**SEQUOYAH FUELS CORPORATION
RESPONSE TO REQUEST FOR
ADDITIONAL INFORMATION
GROUND WATER CORRECTIVE
ACTION PLAN REVIEW**

Subject: Sequoyah Fuels Corporation, Docket – 40-8027
Request for Additional Information – Groundwater Corrective
Action Plan (TAC L52528)

Responses to NRC RAIs of September 28, 2005
Ground Water CAP Review

FIGURE 8-35
 ONE DIMENSIONAL TRANSPORT ANALYSIS, 2356

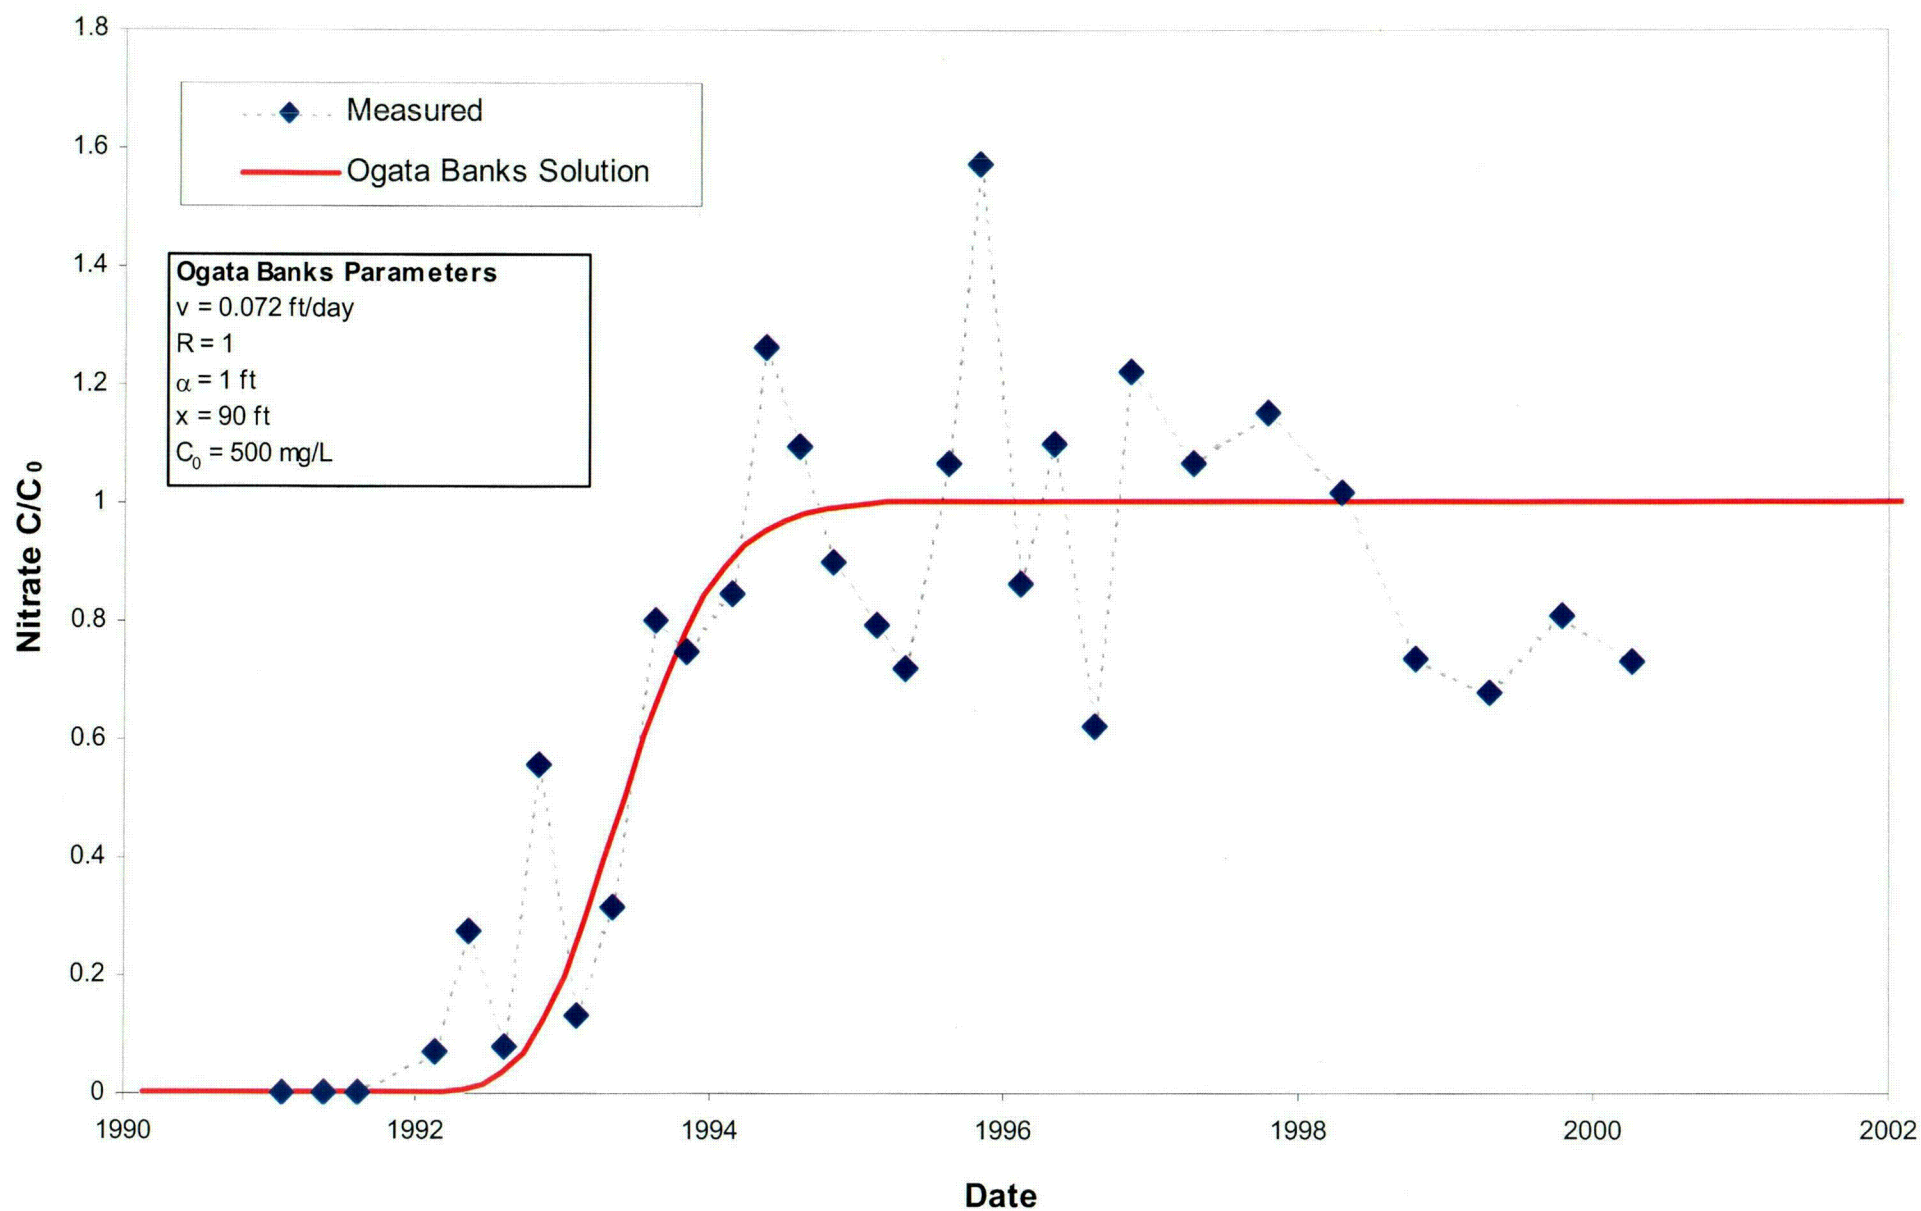
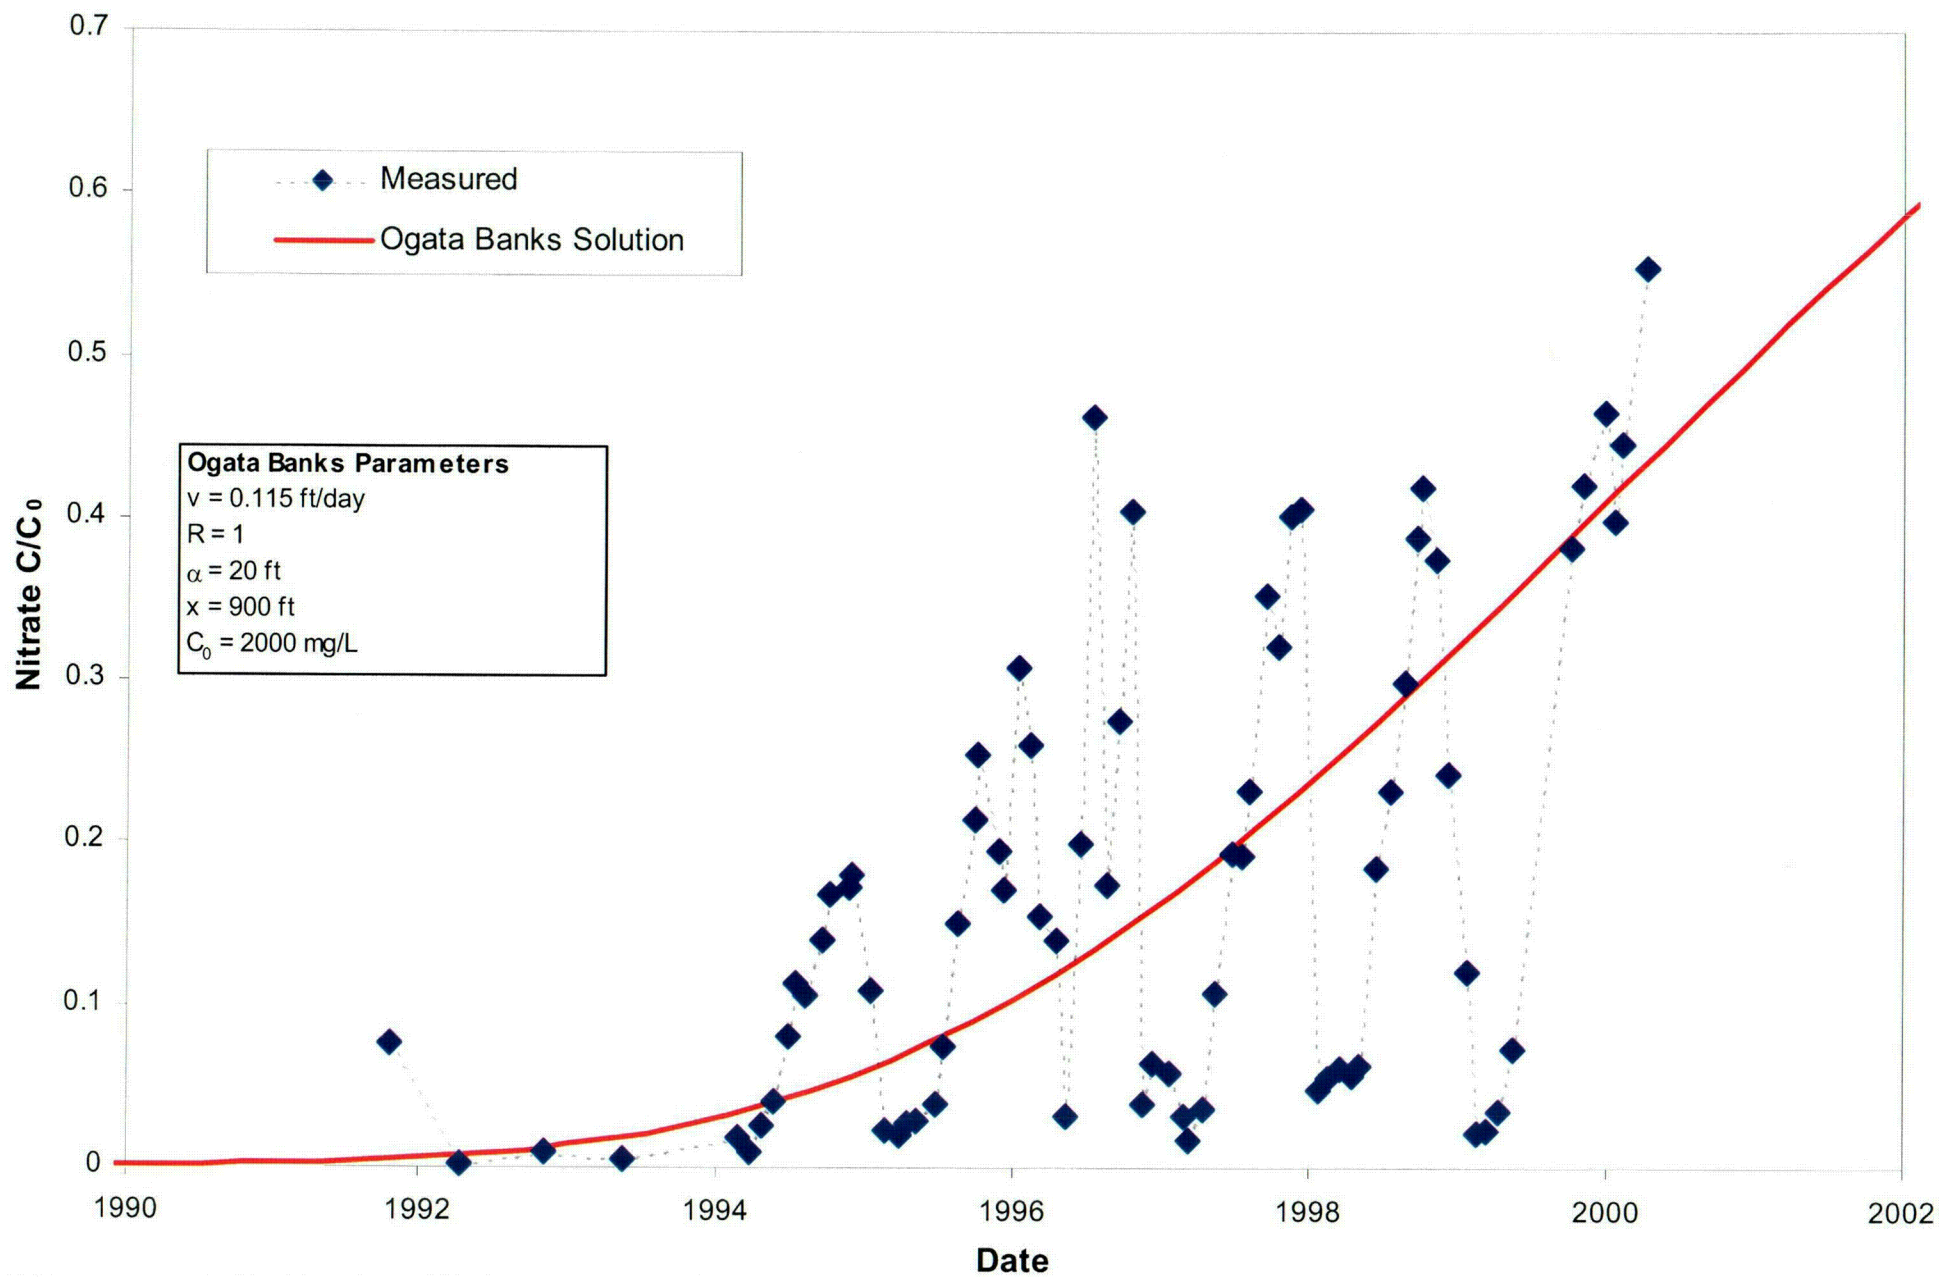
- E. The CAP should include more information regarding contaminant transport, such as dispersivity (longitudinal, vertical, horizontal), retardation factors, and areal recharge rates. Discussions of the geochemical investigations and attenuation mechanisms should also be included in the CAP. SFC should present the most recently estimated values. This information is necessary for evaluating whether the contaminants at SFC would be amenable to the type of remedial actions proposed by SFC.

The longitudinal dispersivity in all layers was initially estimated based on an empirical, scale dependent equation from Xu and Eckstien (1995). The transverse dispersivity and vertical dispersivity were estimated to 10 percent and 1 percent of the longitudinal dispersivity, respectively (Fetter, 1999). Estimated values of longitudinal, transverse, and vertical dispersivity using Xu and Eckstien are 50 feet, 5 feet, and 0.5 feet, respectively. Longitudinal dispersivity values were further evaluated using the Ogata-Banks advection dispersion equation (ADE) solution (HGSCR, Section 8.5.3) and were found to range from 1 foot to 20 feet as illustrated in HGSCR Figures 8-32 through 8-36 (dispersivity = α , Attachment CAP2E-1).

FIGURE 2-5
LOCATIONS OF FACILITY DRAINAGES
AND SEEPS

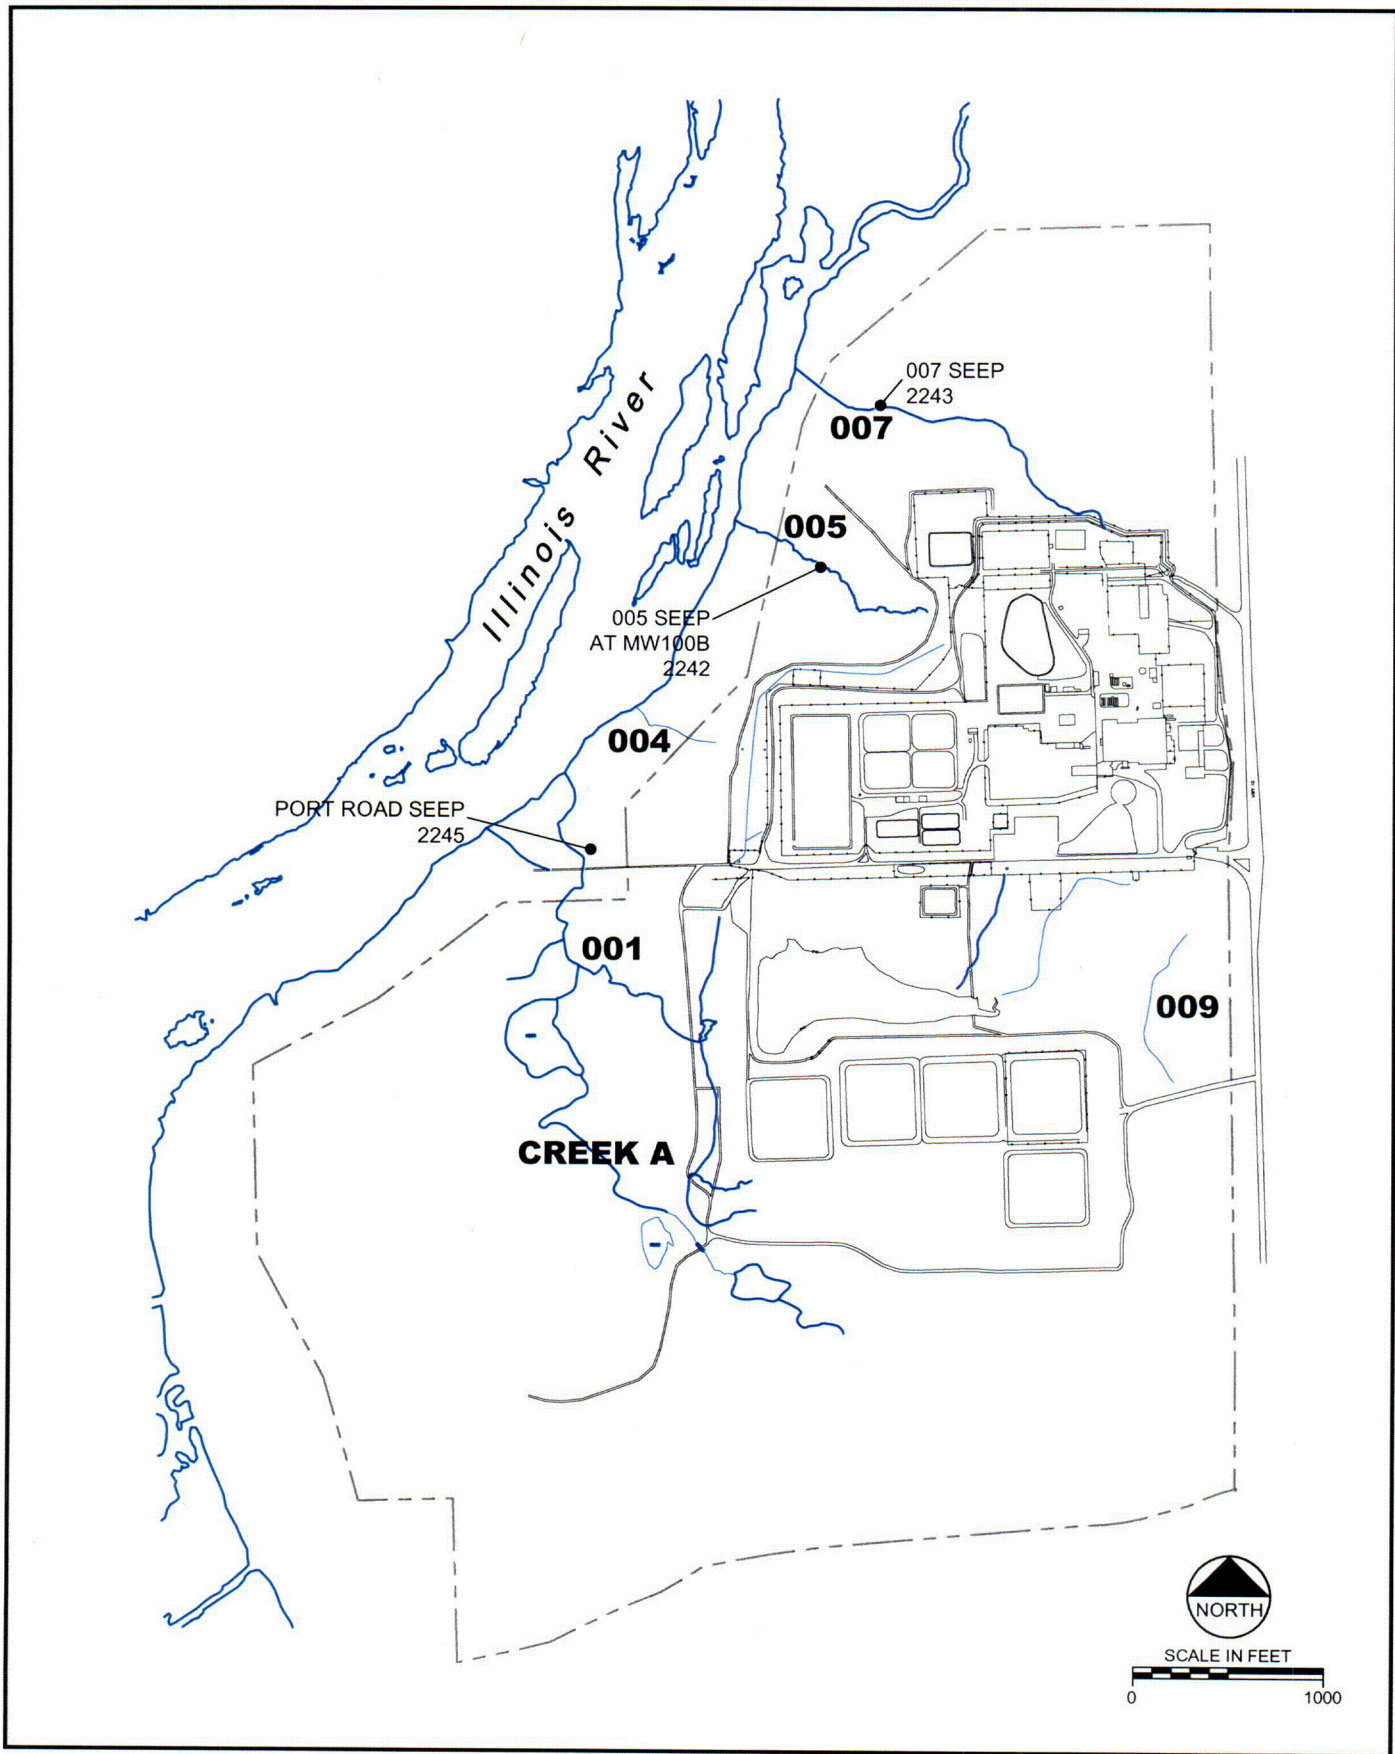
- F. The CAP should include more detailed discussions of the onsite and adjacent surface water bodies and seeps. Information should include flow rates, hazardous constituent concentrations, and surface water body dimensions, if applicable. SFC should also provide a current estimate of pollutant loads entering the Kerr Reservoir. This information is necessary to gauge quantitatively the impact that the current site pollution is having on the reservoir. This is particularly of interest for nitrates and arsenic. Nitrates migrate relatively quickly through ground water, and arsenic is a toxic metal.

The seeps and site drainage surface flows occur seasonally within and along the four primary ephemeral drainages of the site (001, 005, 007 and 008) as identified in the HGSCR. Figure 2-5 from the HGSCR illustrates the locations of the site drainages. Table 2-2 (Attachment CAP2F-1) summarizes the drainage areas and the calculated mean annual flow rates for each site drainage. However, it should be recognized that these drainages run only in direct response to moderate to intense precipitation events and are dry more often than not. Section 2.3.2 of the HGSCR presents the method used to estimate the average annual flow rates for these drainages. Table 2-3 (Attachment CAP2F-1), describes the location and dimensions of the seeps at the time the HGSCR was prepared. Attachment CAP2F-1 also presents seep water quality data for the seeps discussed below.
